Draft

**Proposed redevelopment by Plutus Developments of the former Thomas Peacocke School site, Ferry Road, Rye. RR/2017/1778/P
As amended 10.01.2019**

Demolition of Queen Adelaide public house and erection of 65 residential dwellings comprising 38 houses and 27 flats with associated landscaping, car parking and other infrastructure

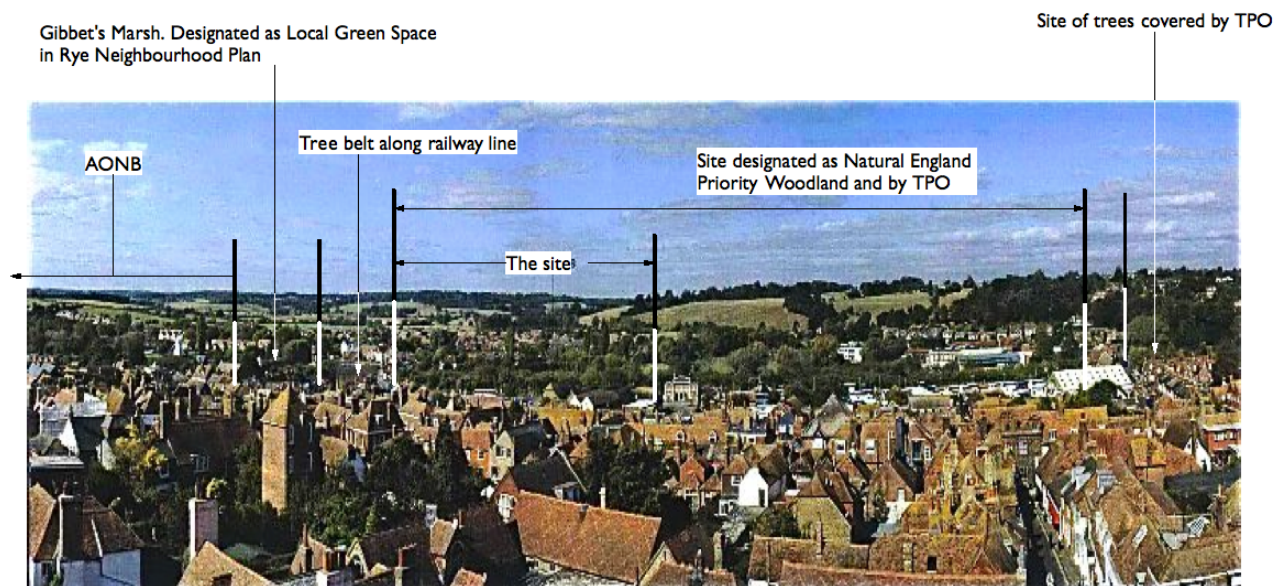
The Society accepts that some reduction, as was granted to both Sainsbury and Tesco, is inevitable but the wholesale obliteration of this protected woodland is unacceptable. See below for comparison of Priority Woodland retained in the Tesco and Sainsbury consents and the current scheme.
